**REVERCHON, S.A. INDUSTRIES, FRANCE
"HIMALAYA"
April 22, 1998**

Subject : Repair of « HIMALAYA » amusement ride

Technical aspects corrective action plan

PROXIMITY SENSOR

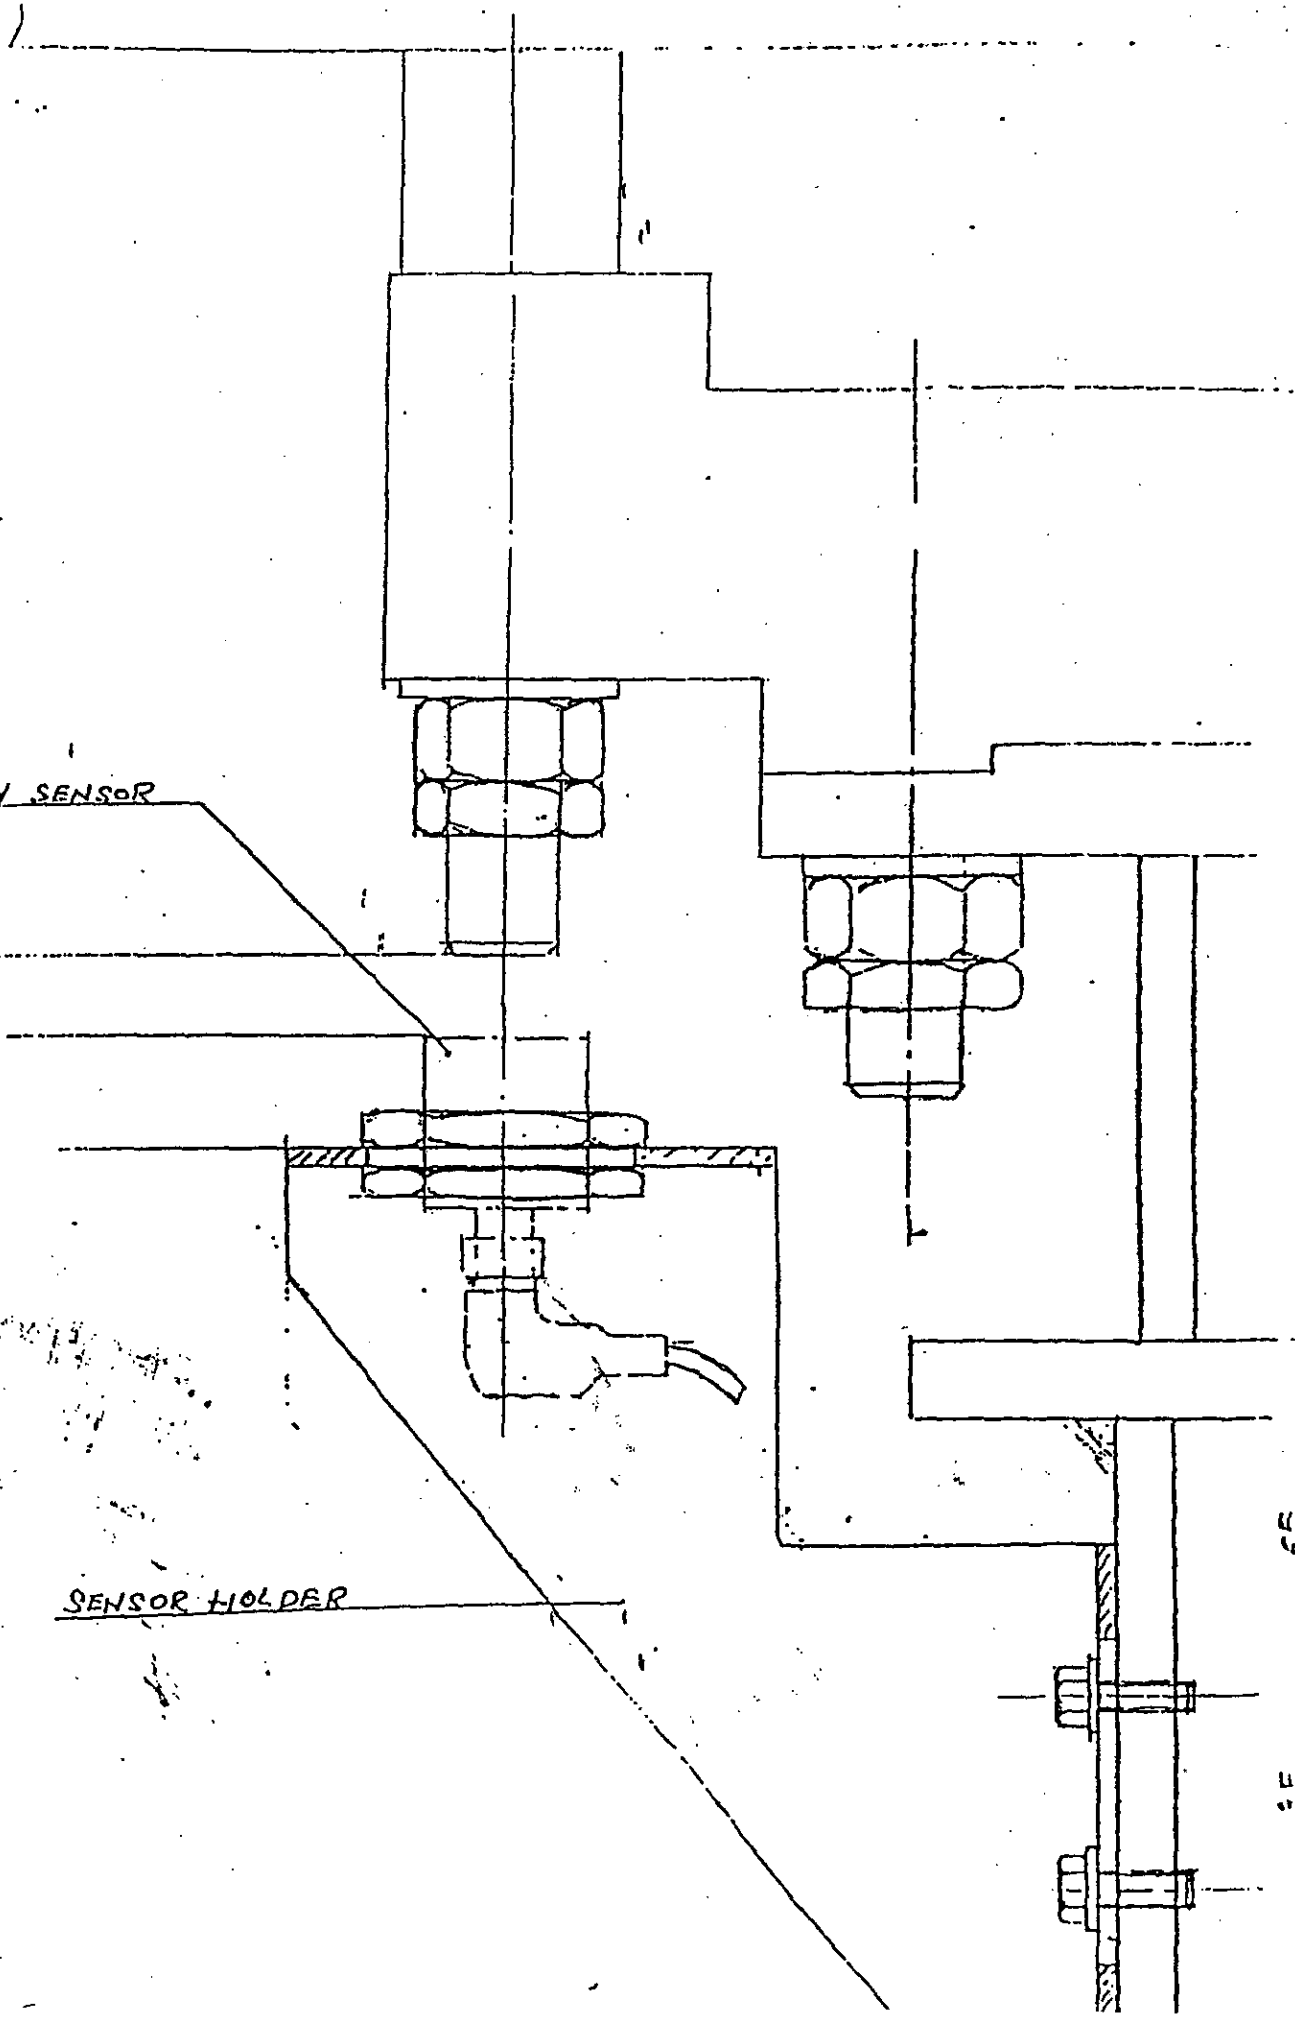
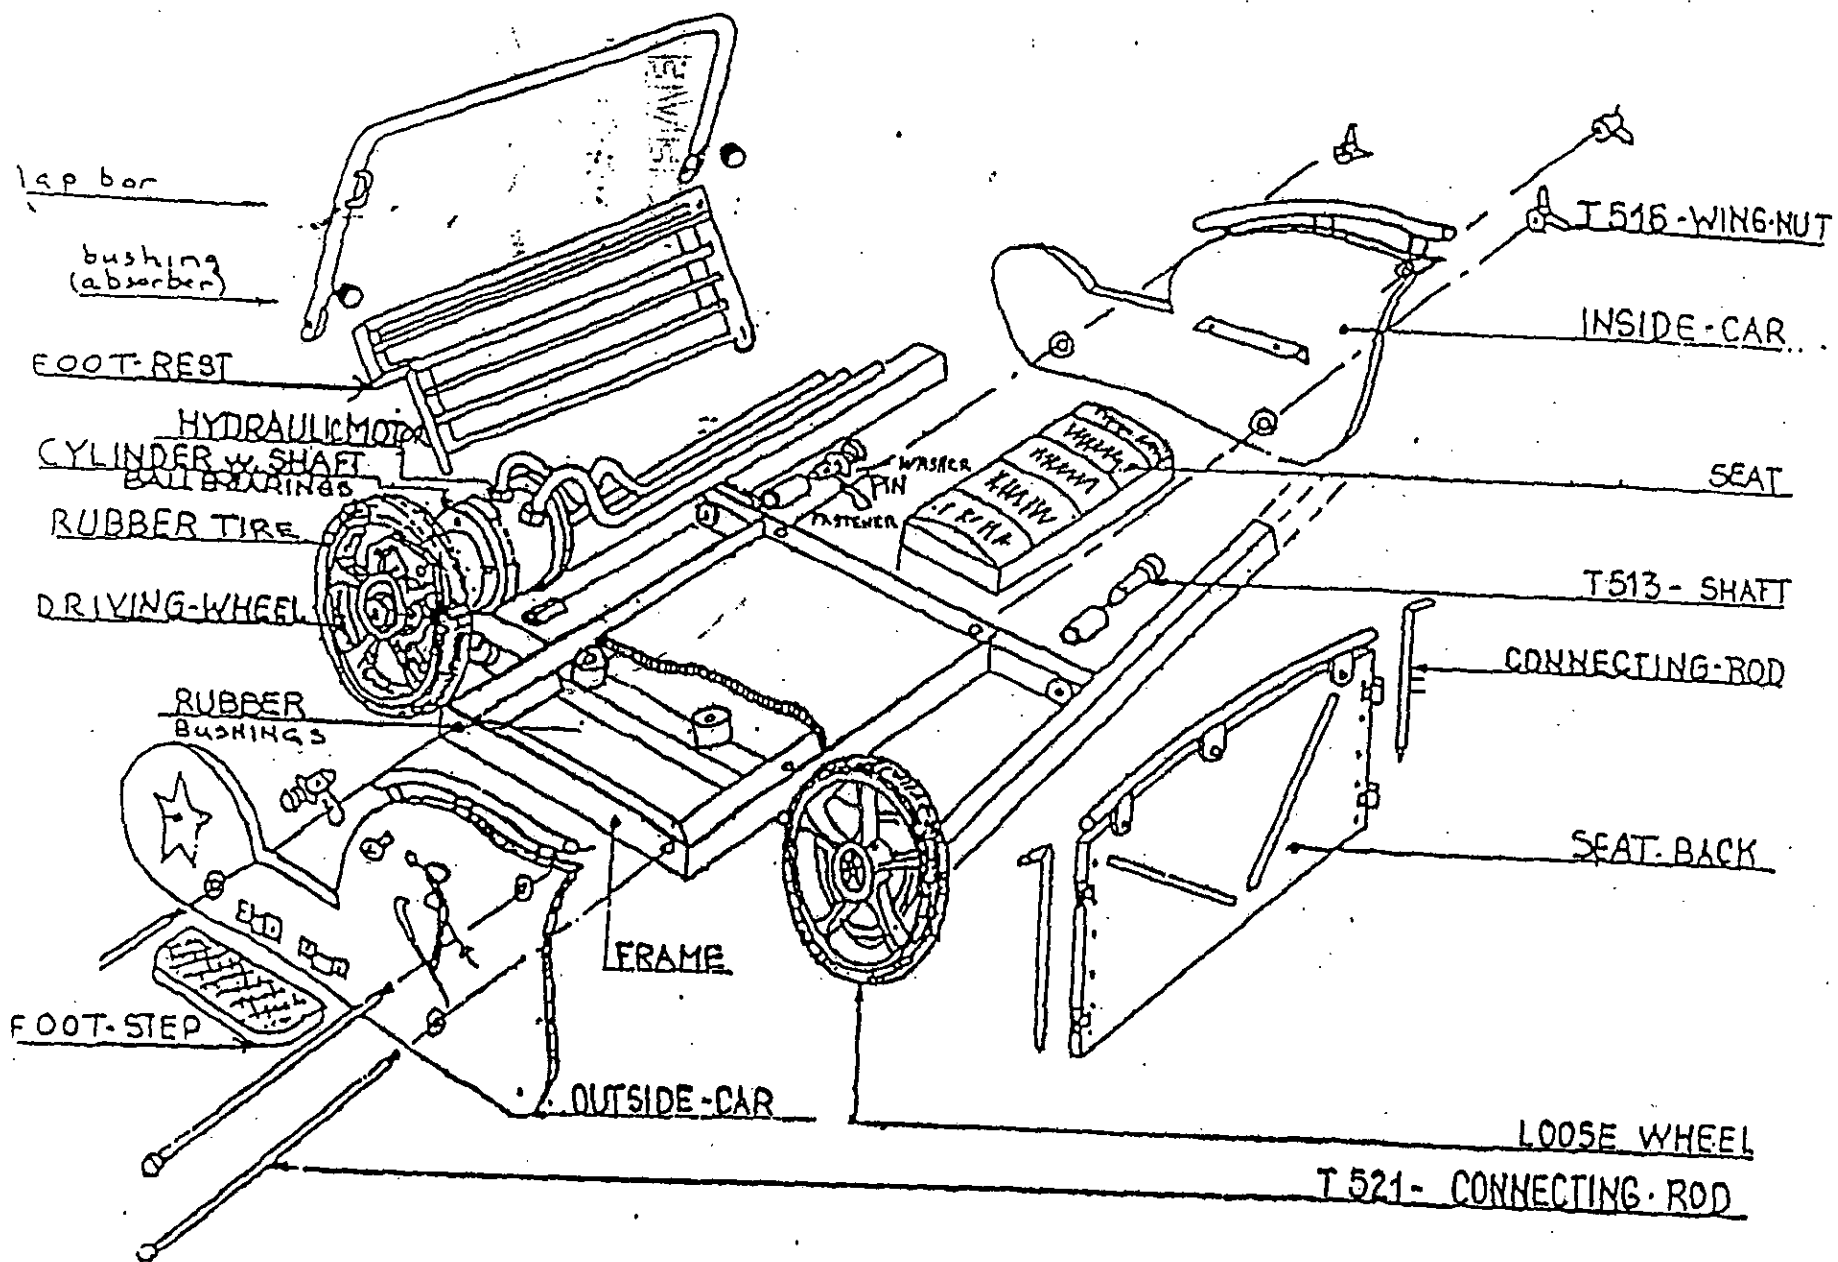
Regarding the speed control device, we propose you to find hereafter 2 detailed main drawings of the installation of a sensor to determine the frequency of the ride.
